DEED REFERENCE: 1489/320  
LOT 8, SECTION 13, A 3774  
WAYSIDE  
ESTATES.  
3RD ELECTION DISTRICT  
HOWARD COUNTY, MARYLAND

LOCATION SURVEY  
#31619 LYNWAY COURT

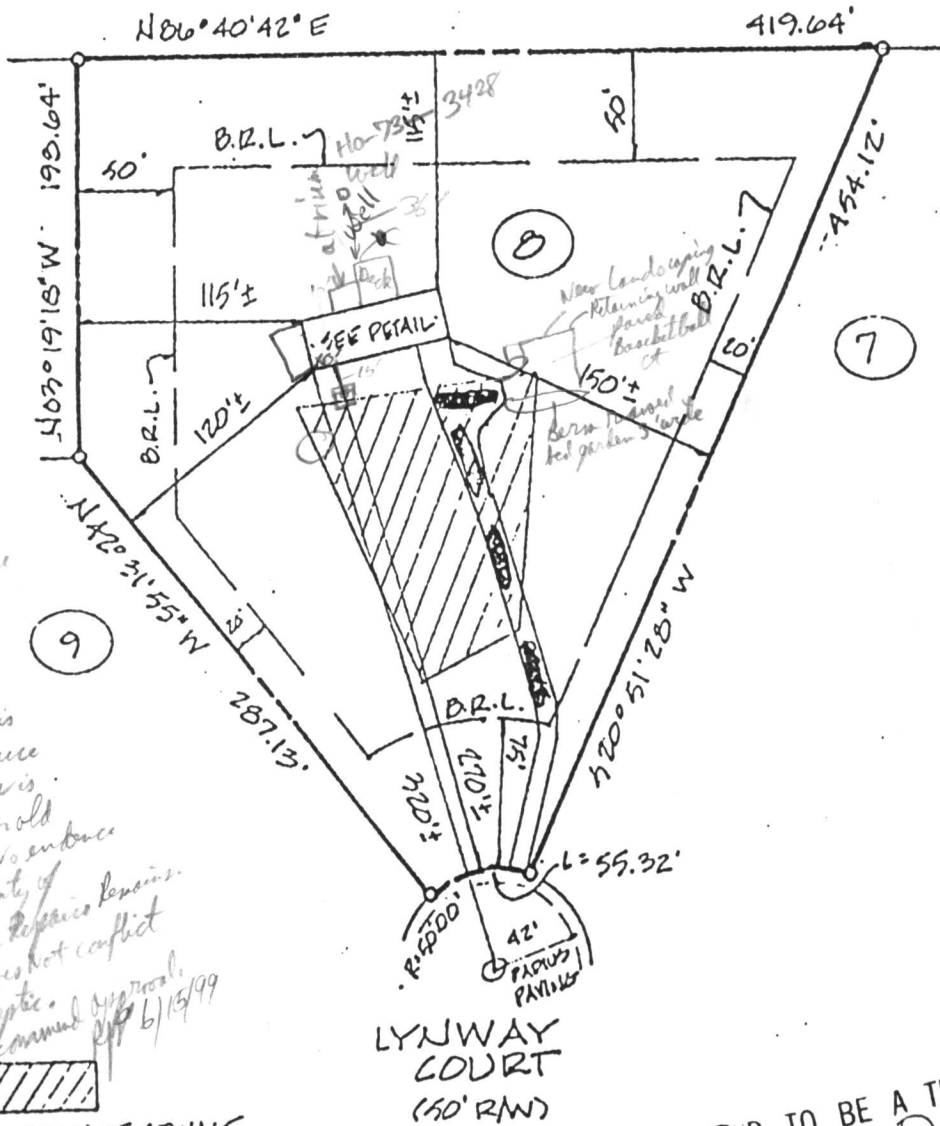
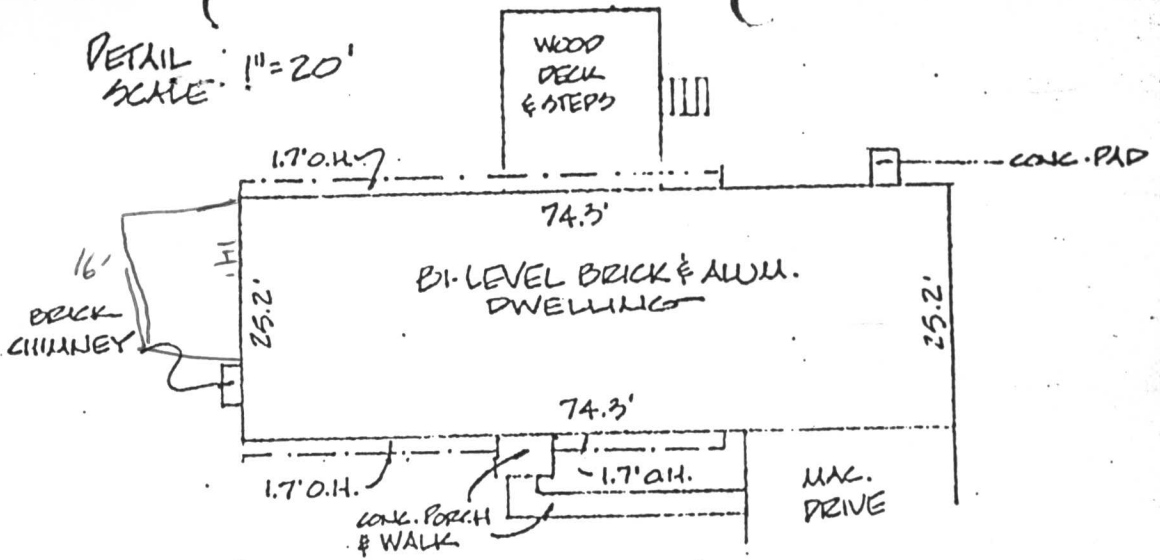
ST. cleanout pipe  
Metal type & metal  
Threaded cap  
No evidence of  
Draywell. There is  
a large Blue Spruce  
growing where Dr. is.  
Suggest to be per old  
Septic permit. No evidence  
of seepage. Photo of  
Pump for future reference.  
Proposed Albs does not conflict  
with well or septic.  
Recommended approval  
6/15/99

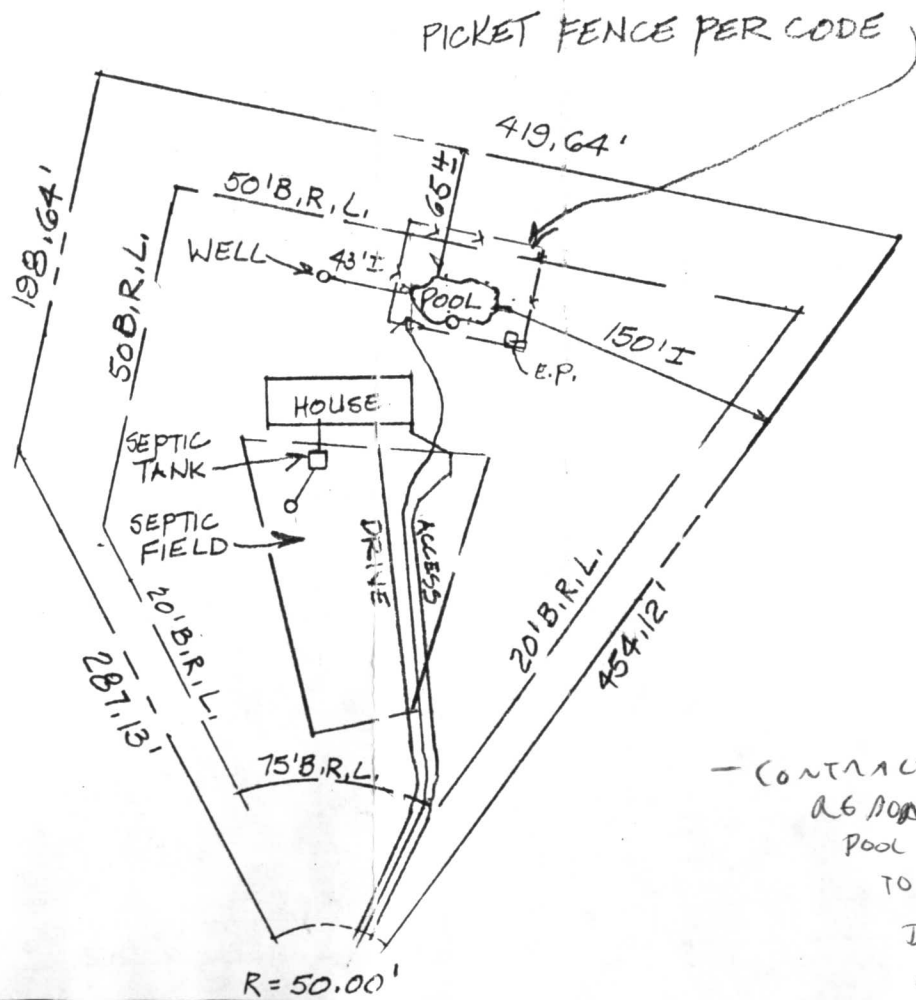
7/20/09  
 Pool location  
 OK AS SHOWN.  
 JS

- CONTRACTOR  
 AS NOTED EXCAVATION FOR  
 POOL LOCATION CHANGED  
 TO WITHIN 11' OF WELL  
 DUE TO TREE AT INTENDED  
 POOL LOCATION.
